# UNITED STATES PATENT AND TRADEMARK OFFICE

APPLICATION NO.	FILING DATE	FIRST NAMED INVENTOR	ATTORNEY DOCKET NO.	CONFIRMATION NO.
09/965,990	09/28/2001	Jerry L. Carlson	98-HSP-245	4857

## Office Action Summary

## **DETAILED ACTION**

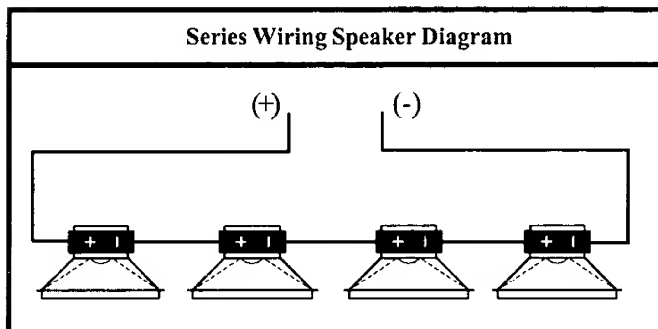
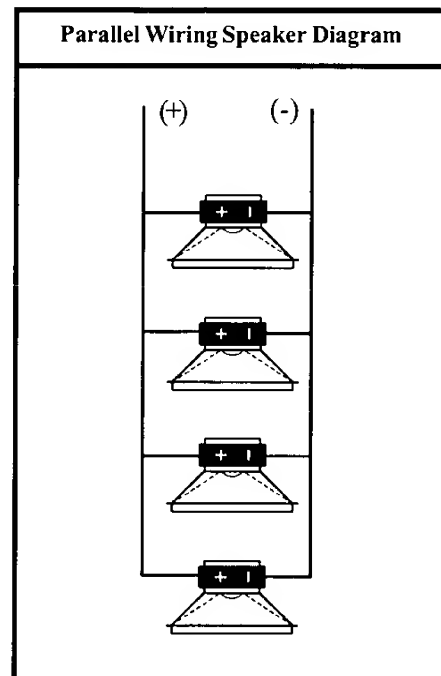
Re: claim 1, line 9, "a filter assembly disposed in series flow relationship" is inaccurate because disclosed filter assembly is in a parallel arrangement (see attachment).

9. The applicant argues “it can be seen clearly from the schematic of fig. 2 that in fact the filter assembly (81) is in a series flow relationship between the source of fluid C and the various outlets and inlets (63 and 65),” which is not claimed. The claim sets forth “a filter assembly disposed in series flow relationship in said flow path,” the claim further sets forth “said flow path including in order, said source, said pump inlet, said pump outlet, said motor inlet, and said motor outlet.” The filter assembly, however, clearly is in a parallel relationship in said flow path. Included in the action is a schematic of series and parallel relationships, as exhibit A. The illustrations in exhibit A show parallel and series diagrams. Since the oil in the instant invention is allowed to flow in more than one flow path, it is not defined as a series relationship. Until oil

is lost in the system no oil will enter from the source and the filter, because this is the case oil will not be filtered between motor and pump each and every time during operation, thus it is in a parallel relationship.
